International Code Council

**ICC 500-2020 edition
Public Input Agenda with
Committee Votes and Public Comments
based on input received
on 2014 edition of the
ICC 500 Standard**

**For February, 2020
2nd Meeting – Teleconference**

Figure 504.1.1

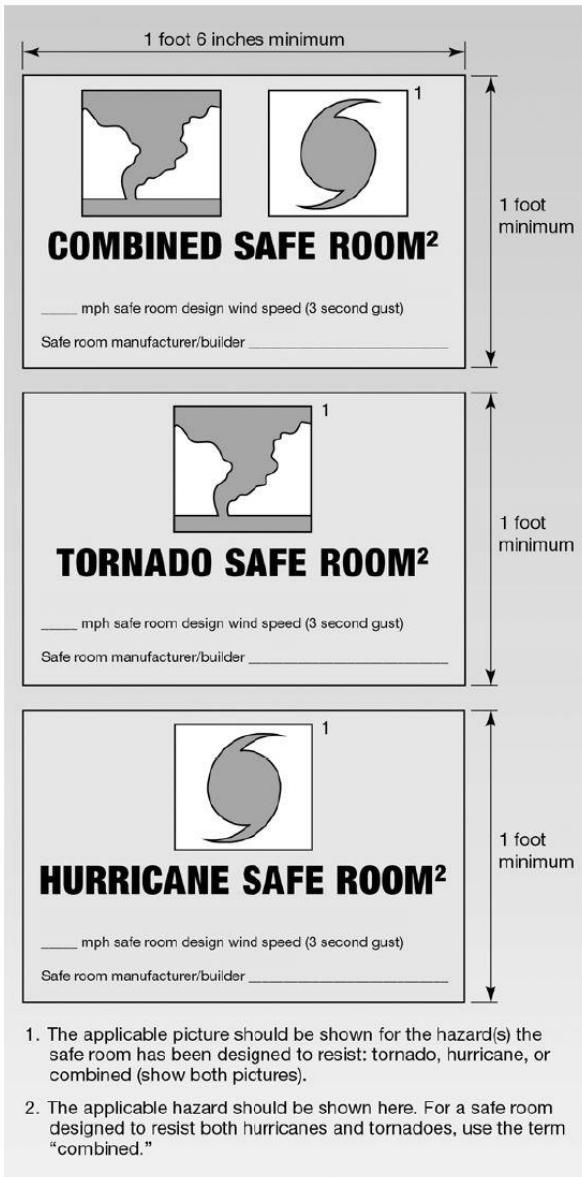
Staff Note: Modifications were also submitted for Commentary Figure 504.1.1 and 504.1.2

Add “Tornado Shelter Design Capacity: 1,500” to Figure 504.1.1.

Add “Tornado Shelter Design Capacity: 2,500” and “Hurricane Shelter Design Capacity: 1,500: to the top sign in Figure 504.1.2.

Add “Tornado Shelter Design Capacity: 400” to the middle sign in Figure 504.1.2.

Add “Hurricane Shelter Design Capacity: 2,000” to the bottom sign in Figure 504.1.2.

Committee Action: As modified (7-0 meeting) (12-0 electronic vote)

FIGURE ~~303.2~~ 303.1.1

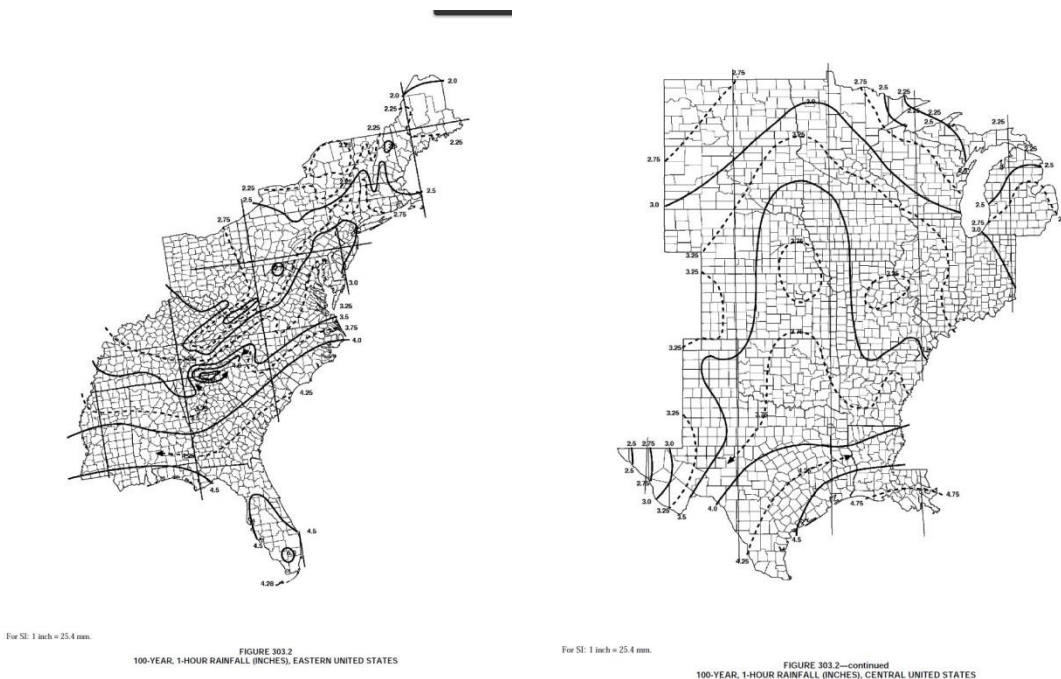
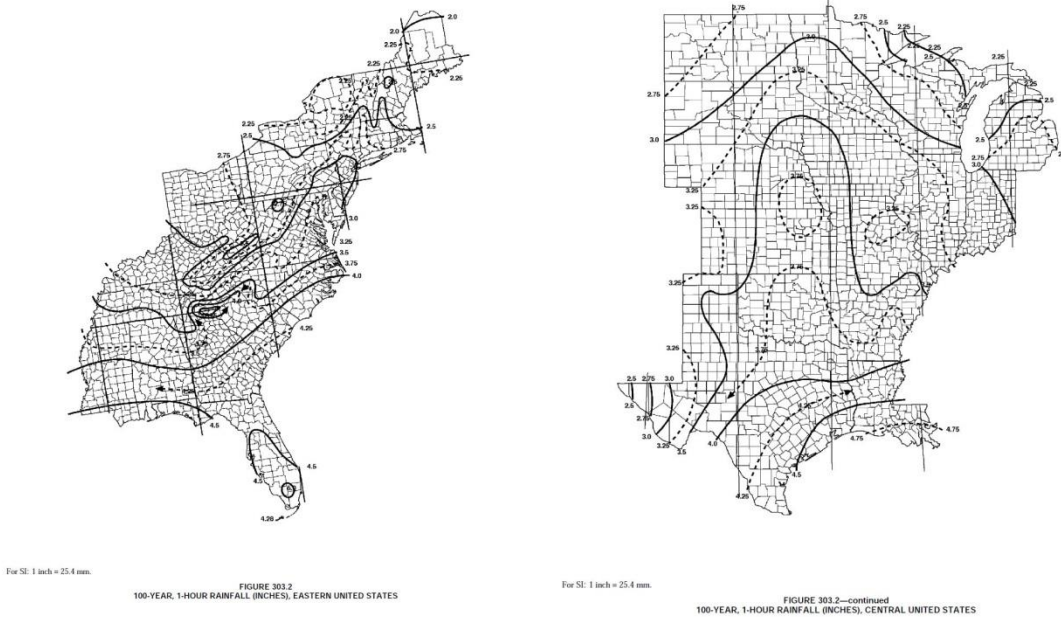
303.1.1. Rainfall rate. The rainfall rate shall be determined by adding 6 inches (152.4 mm) of rainfall per hour to the rainfall rate established from Figure ~~303.2~~ 303.1.1.

Reason: Figure 303.2 is referenced in Section 303.1.1 and not in Section 303.2. Section 303.2 has nothing to do with the figure.

Committee action: Approval as Further Modified		
	Affirmative	Affirmative with comment	Negative with comment	Abstain with reason
Schultz Vote:		x		
<p>Your comment/reason: 303.1.1 Rainfall rate states “or from approved local weather data”. It is unclear who is the approver of this data?</p> <p>No revisions suggested.</p> <p>303.1.1. Rainfall rate. The rainfall rate shall be determined by adding 6 inches (152.4 mm) of rainfall per hour to the 100-year, 1-hour rainfall rate. The 100-year, 1 hour rainfall rate shall be determined from Figure 303.1.1 or approved local weather data.</p>

Committee action: Approval as Further Modified		
	Affirmative	Affirmative with comment	Negative with comment	Abstain with reason
Scott Vote:		x		
<p>Your comment/reason: Editorial – “Western” in Western United States map caption is spelled wrong (Westerm)</p> <p>Revise as follows:</p> <p>FIGURE 303.1.1—continued 100-YEAR, 1-HOUR RAINFALL (INCHES), WESTERN WESTERM UNITED STATES</p>

Figure 304.2(2) SHELTER DESIGN WIND SPEEDS FOR HURRICANES

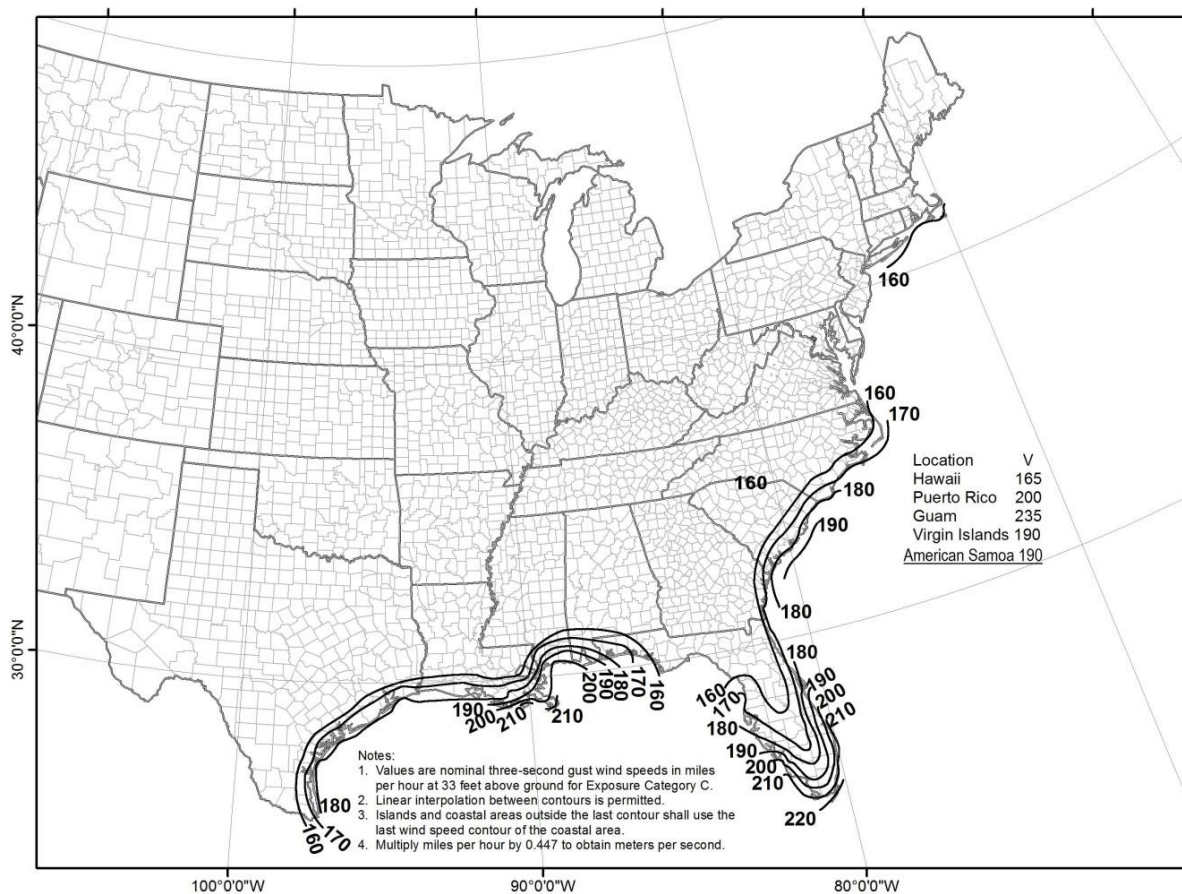
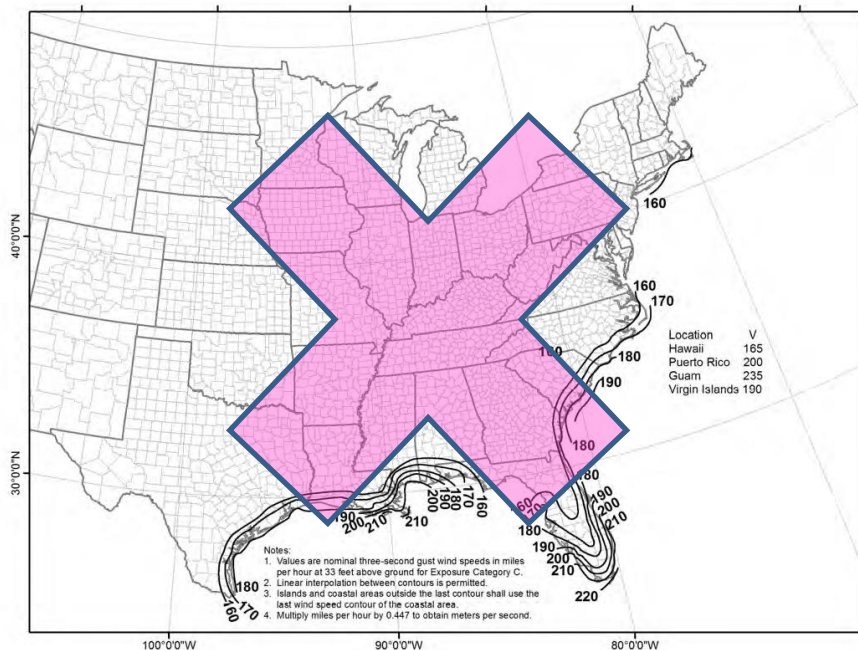
Reason: Currently Figure 304.2(2), the Shelter Design Wind Speeds for Hurricanes, does not specify a design wind speed for American Samoa where hurricanes are the greatest high wind hazard, and a 10,000 year MRI analysis is not currently available. From the ASCE 7 wind speed maps for 300, 700, 1700, and 3000 years, it turns out that the Virgin Islands and American Samoa wind speeds at each of these return periods are almost identical, meaning the hazard curves have a similar shape at the two locations. On the ASCE 7-16 Risk Category IV map,

American Samoa and the US Virgin Islands both have design wind speed of 180 mph. Therefore, the proposed wind speed for American Samoa is the same as the 10,000 year MRI wind speed that is currently used for the US Virgin Islands, 190 mph.

Committee Action: Approved as Modified (10-0)

Notes: Will also revise name for US Virgin Islands and add Commonwealth of the Northern Mariana Islands and American Samoa to full map. ARA will provide revised map for standard.

Rotate maps to landscape in final draft.

FIGURE 304.2(2)
STORM SHELTER DESIGN WIND SPEEDS, V , FOR HURRICANES

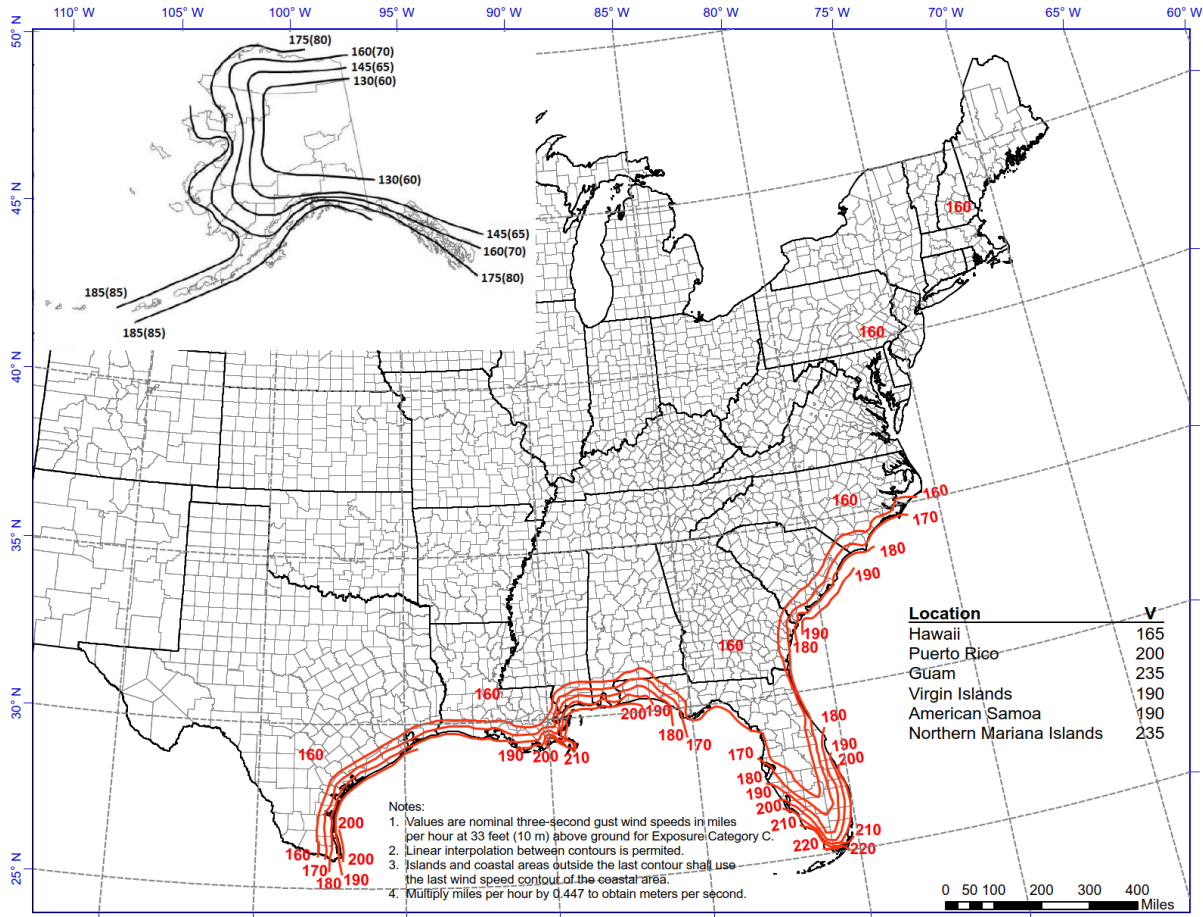
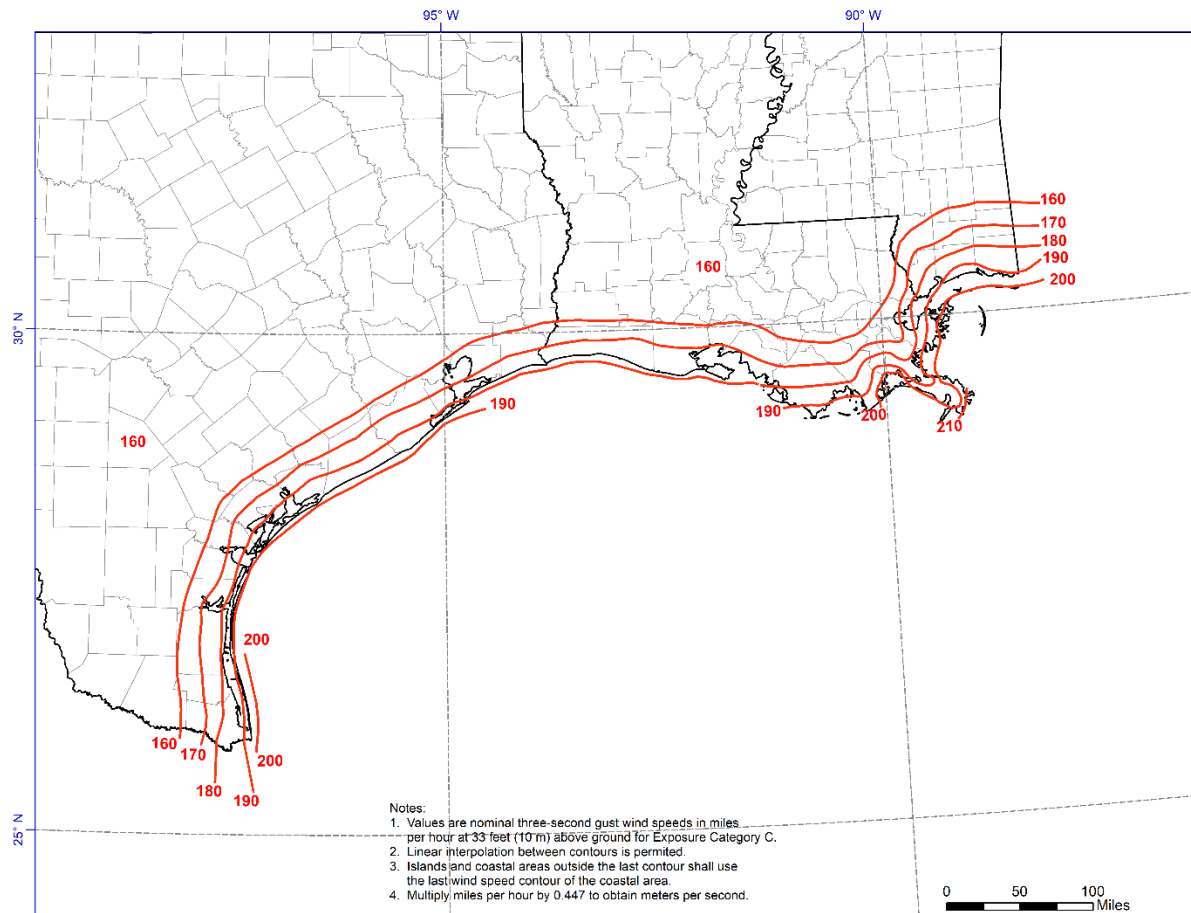
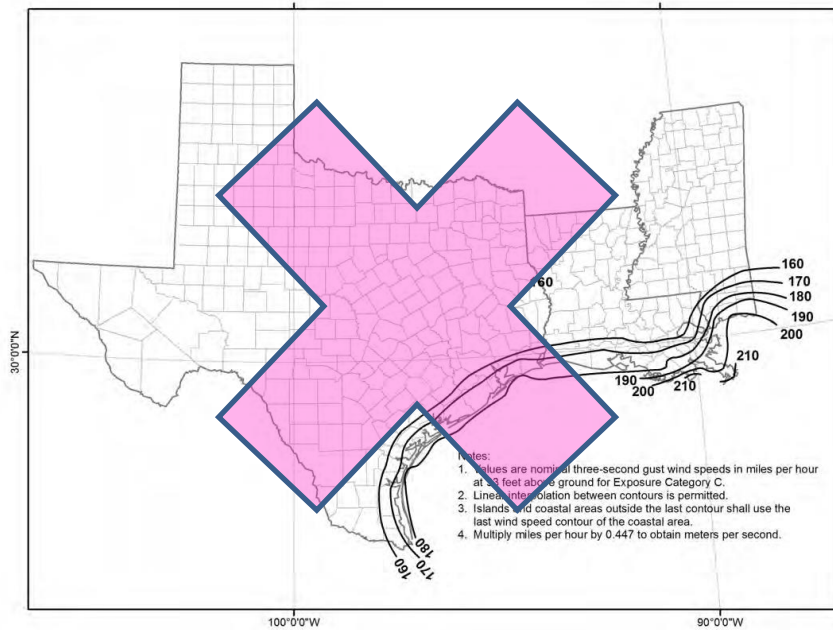
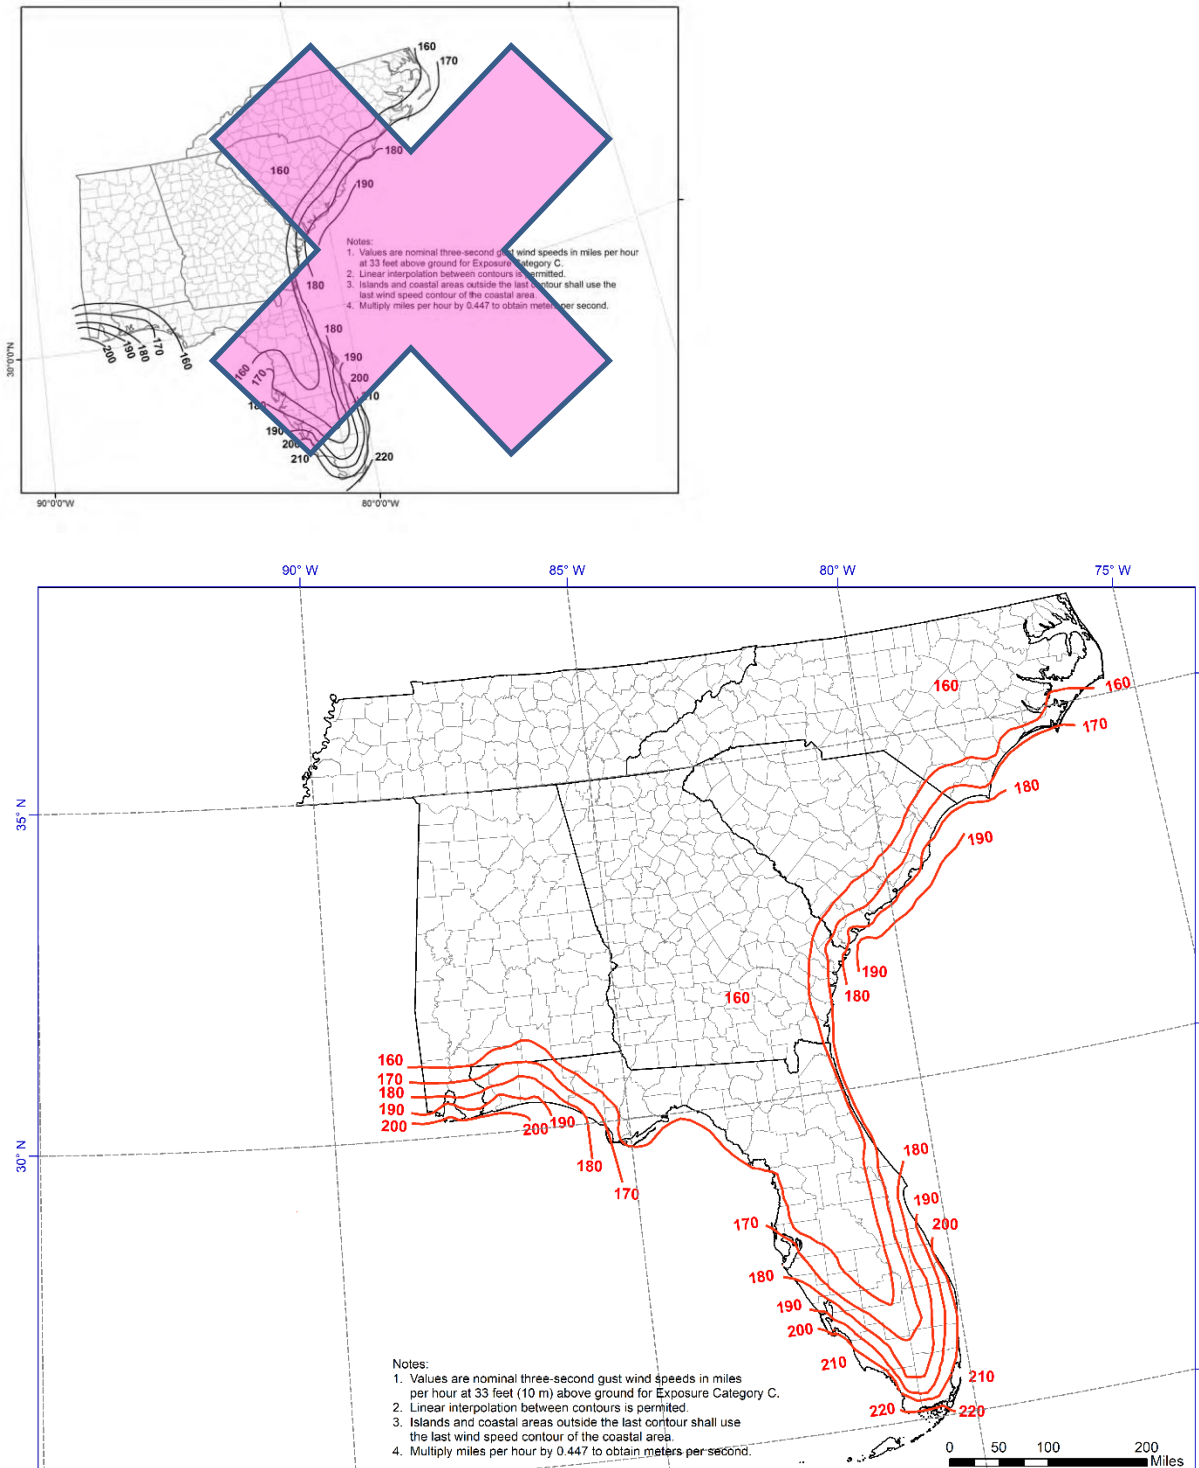
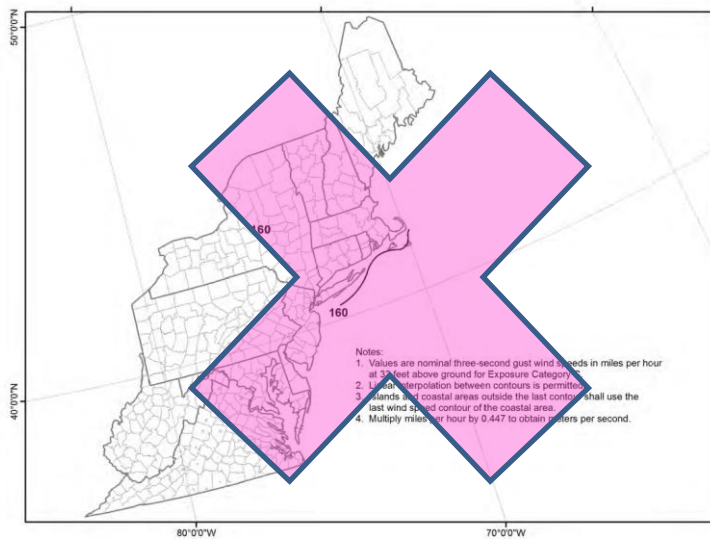
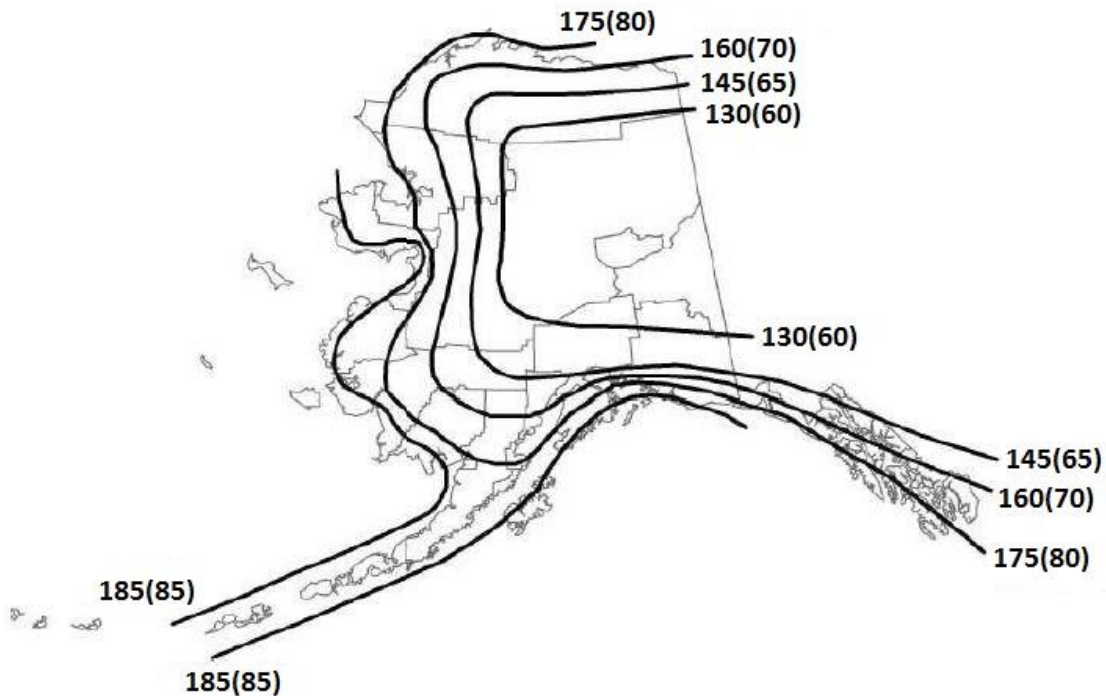
Delete four current maps and replace with the following

Committee Reason: Revised maps to coordinate with latest information for hurricane winds. Add Alaska because that state is affected by hurricane winds. Full list of islands is needed.

Committee action: Approval as Modified		
	Affirmative	Affirmative with comment	Negative with comment	Abstain with reason
Scott Vote:		x		
<p>Your comment/reason: Editorial – does it need to list the full name of the “Commonwealth of the Northern Mariana Islands” on Figure 304.2(2)?</p> <p>Also note in the committee action and I don’t see the footnote: Add footnote with reference to wind speeds that are electronically available at ATC – Marc Levitan will provide electronic address.</p> <p>Staff note: See Levitan comments for IS-STM 03-09-18</p>

FIGURE 804.9.5(3)
ROLLING DOOR ASSEMBLIES

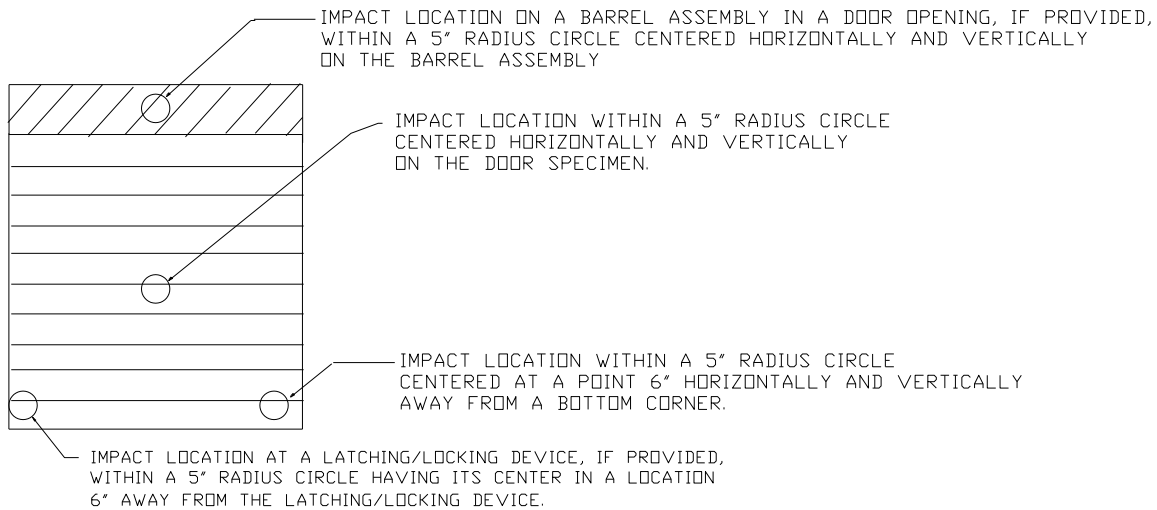
For rolling door assemblies, the door shall receive two impacts as shown in Figure 804.9.5(3) plus an additional impact on a latching/locking device if provided, plus an additional impact on a barrel assembly if mounted in the door opening.

Reason: Clarify application of door impact provisions with respect to testing of rolling and sectional doors
